Technical Service Bulletin: TSB130160

New QST30 Rear Deep Sump Application Oil Suction Tube and Brackets

Figure 1. Revised suction tube (1), block bracket (2), vertical bracket (3)

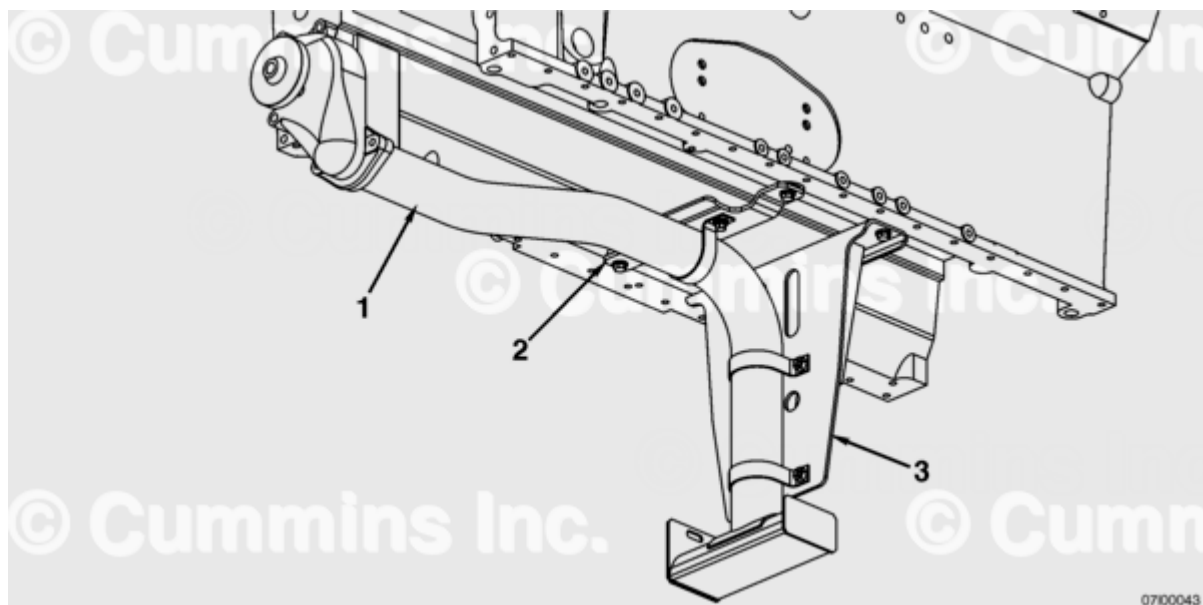
This document introduces a new lubricating oil suction tube and brackets for QST30 rear deep sump application; Option OP5137 **only**. The oil suction tube and brackets have been designed to prevent cracking of the oil suction tube caused by vibration.

The improved tube assembly includes brackets brazed onto the suction tube, as well as changes to the vertical and block brackets. The new brackets must be used with this revised tube and include slots for the capscrews to improve alignment with the tube clamps. A nominal 1 mm [0.039 in] gap is designed to space the tube away from the brackets, to prevent fretting between the tube and the brackets.
